**1997 AMENDMENTS TO
SEWER SYSTEM RULES AND REGULATIONS**

TYPICAL DETAIL
SERVICE CONNECTION
TO SANITARY SEWER

PLATE I

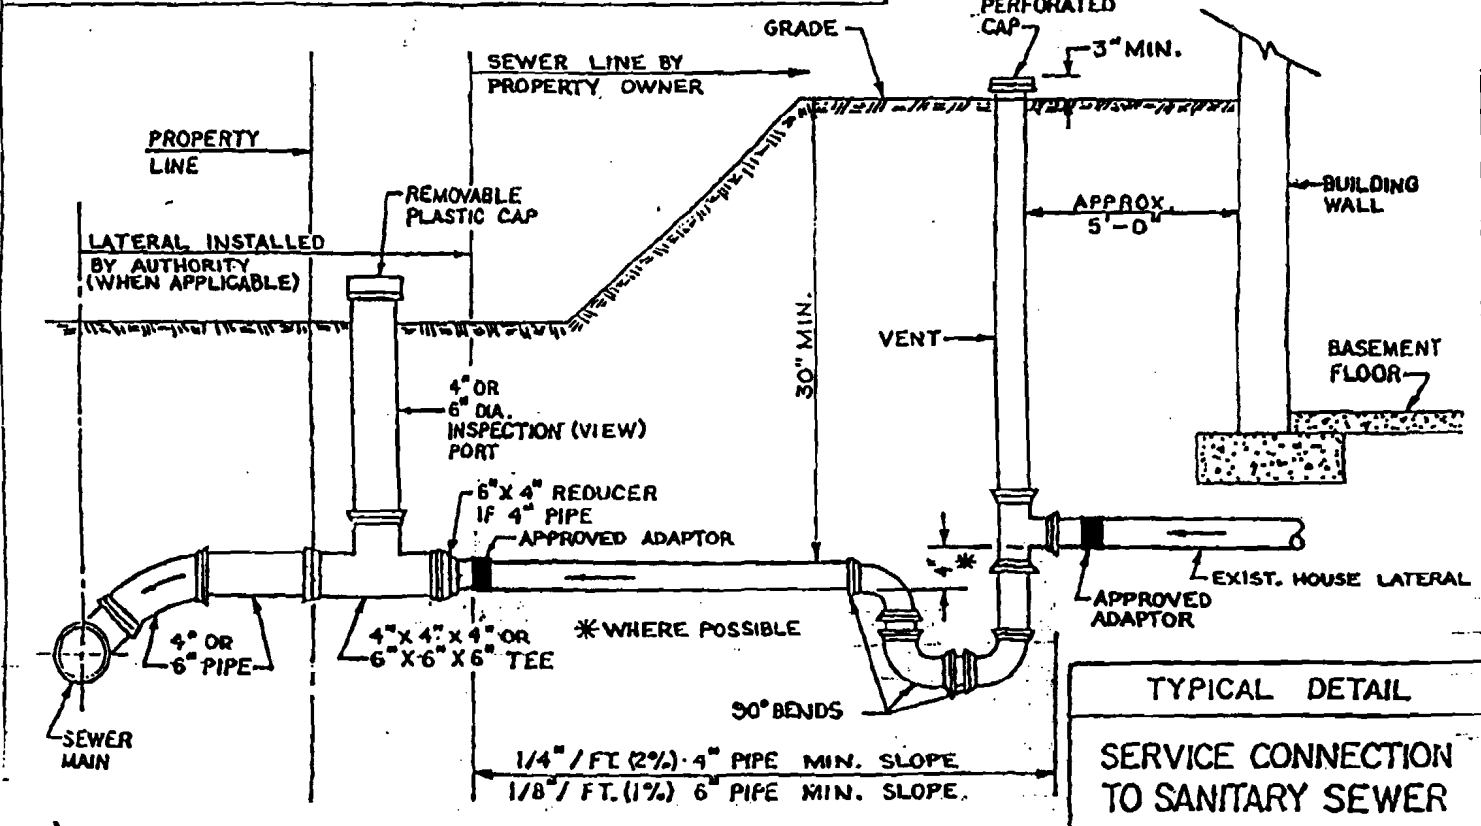
2. Section 913.1 is added to the Sewer System Rules and Regulations dated July 23, 1990, as follows:

Section 913.1. The Supervisors may from time to time approve one or more drawings, sketches or examples of a typical sewer connection. Notwithstanding the other provisions hereof, building connections complying with an approved sketch or plan of a typical sewer connection shall be acceptable, provided that any matter not fully covered by such sketch or plan of a typical sewer connection shall be in accord with the terms of these Rules and Regulations and further provided all Authority Rules and Regulations are complied with. As an example, the Supervisors hereby adopt as a sketch or plan of a typical sewer connection the sketch attached hereto as Exhibit A until such time as the Supervisors shall, by resolution, replace said sketch with a different sketch. This provision is subject to the overriding provisions of Section 7 of Ordinance No. 80, as added by Section 1 of Ordinance No. 86, providing for compliance with the Sewer System Rules and Regulations of the Windber Area Authority.
